MEETING:	PLAN COMMISSION
DATE AND TIME:	<u>MONDAY, JANUARY 11, 2016 6:30 p.m.</u>
LOCATION:	Germantown Village Hall Board Room

1/11/16 Plan Commission Meeting

Village Planner Report

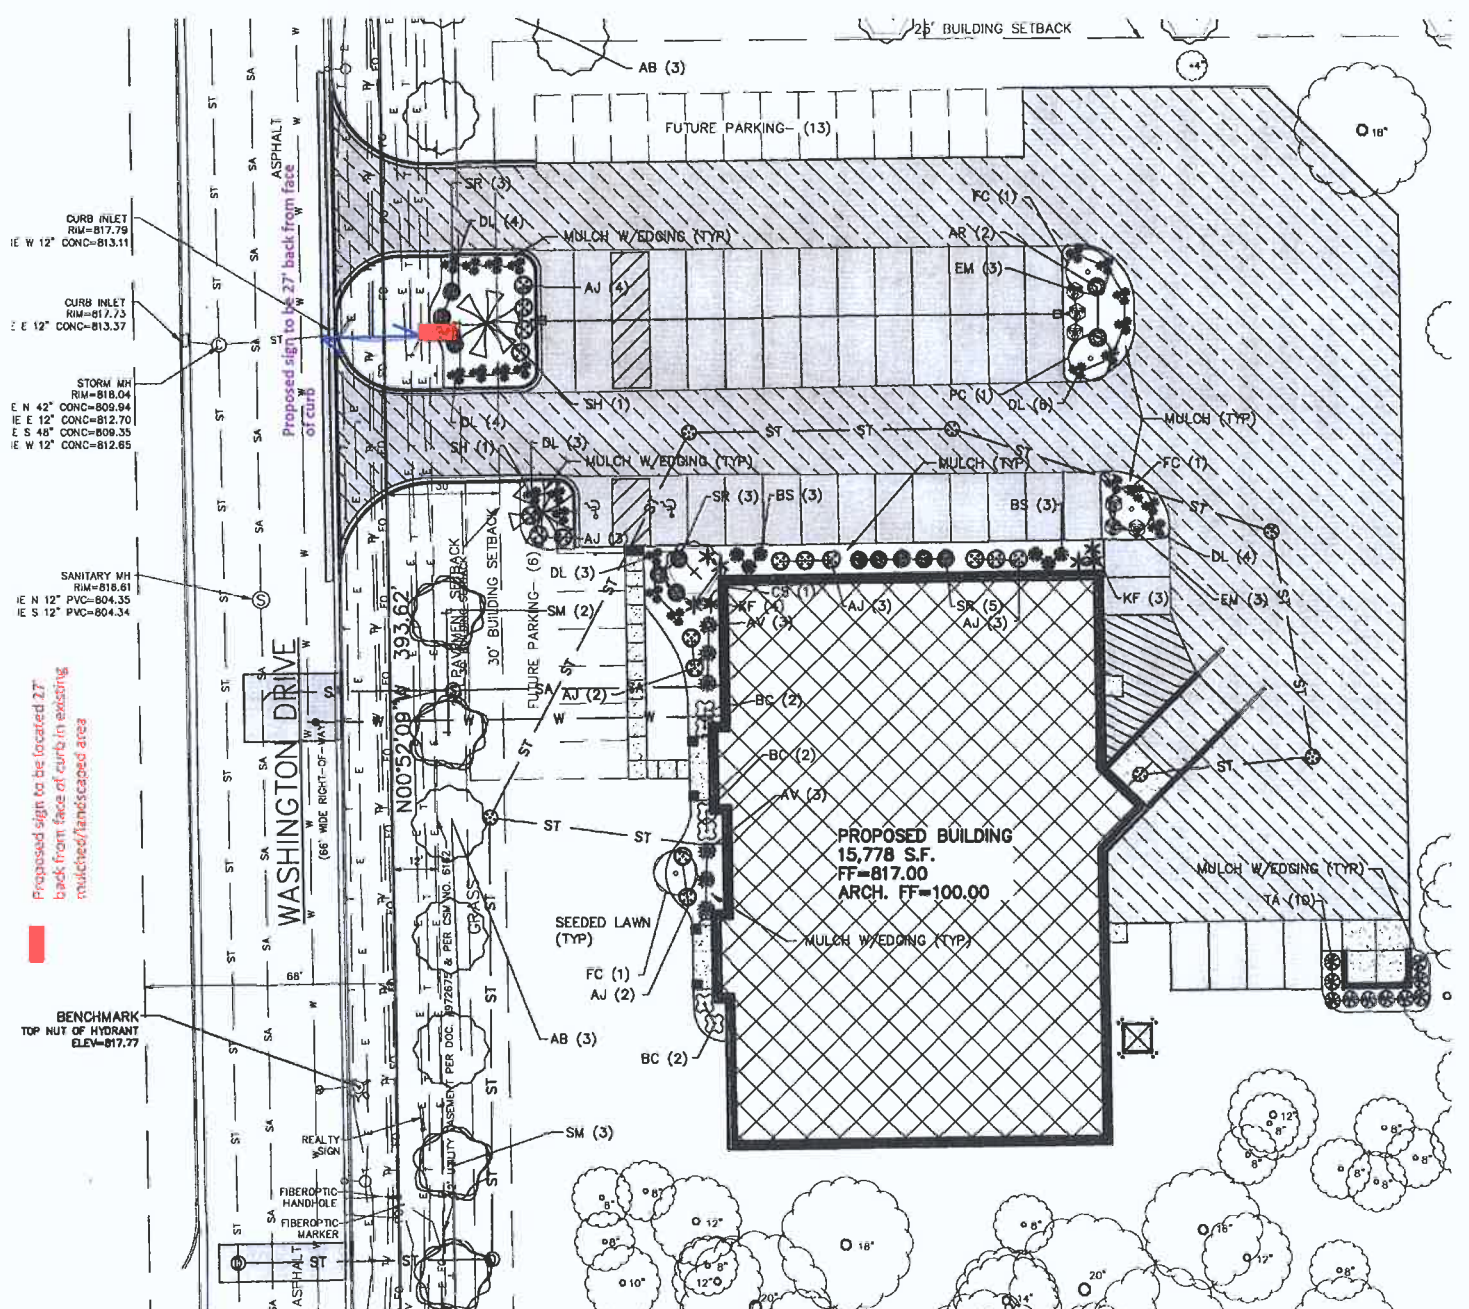
The proposed monument sign meets the applicable Village requirements. However, the property owner has indicated that, although capable, the sign is not intended to be internally illuminated at this time. The specifications do not indicate the white panels are opaque, so, if the sign is internally illuminated in the future, the sign panels will need to be opaque.

1. In the future, if the sign is internally illuminated, the sign panels with the white background shall be opaque or dark in compliance with the Village's sign regulations.

SHEET 1 OF 4

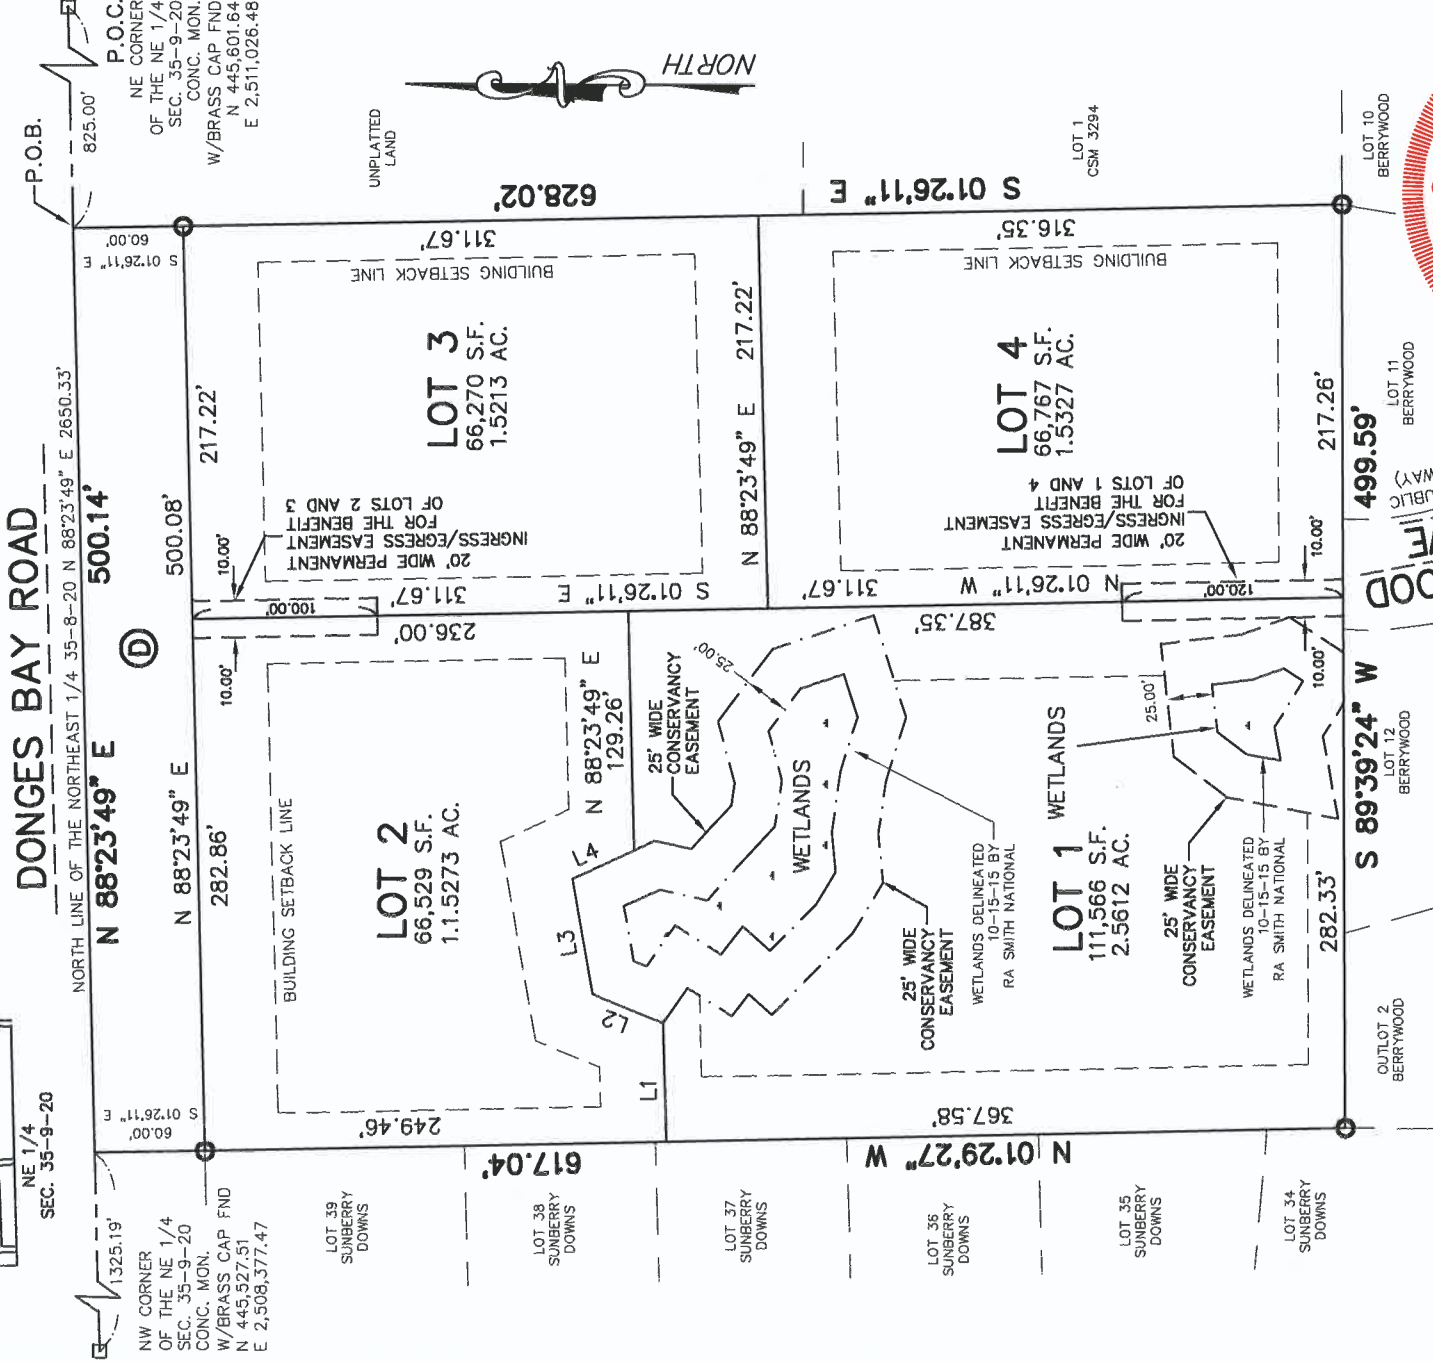
The existing Rs-4 zoning and 4-lot layout are arguably consistent with the general intent of the 2020 Land Use Plan map “Low Density Residential” classification, but not necessarily consistent with the density and lot sizes of other pre-existing development in the same “low density residential” area. Further, one might argue that a development plan that does not include an extension of Gatewood place does not necessarily comply with the “...*should be required to develop or connect to the existing system of collector and local roads... and not have direct access to arterial roads...*” provision in the plan.

As was included in the original plan, development of this parcel was intended to continue and/or complete the practice and pattern of constructing and extending local streets through the various residential subdivisions in the area to provide multiple means of access to/from the residents to the various collector and arterial streets in the vicinity (i.e. Donges Bay Road, Fond du Lac Avenue and County Line Road).

With respect to the above criteria, the extension of Gatewood Place is a planned extension. The Berrywood subdivision to the south was approved for development in 2004 with cul-de-sacs that exceed the maximum 500' length requirement. That development was only allowed to proceed given another provision in the Subdivision regulations that allows cul-de-sacs greater than 500 feet in length if the road is extended to the property line adjacent to another property such that the road can be further extended and connected to another roadway such that the resulting cul-de-sacs (once all are completed) do not exceed a length of 500 feet.

The Fire Department is recommending that Gatewood Place be completed/extended through to Donges Bay Road to provide improved access to the subject parcel and to the existing residential area to the south (Berrywood and beyond).
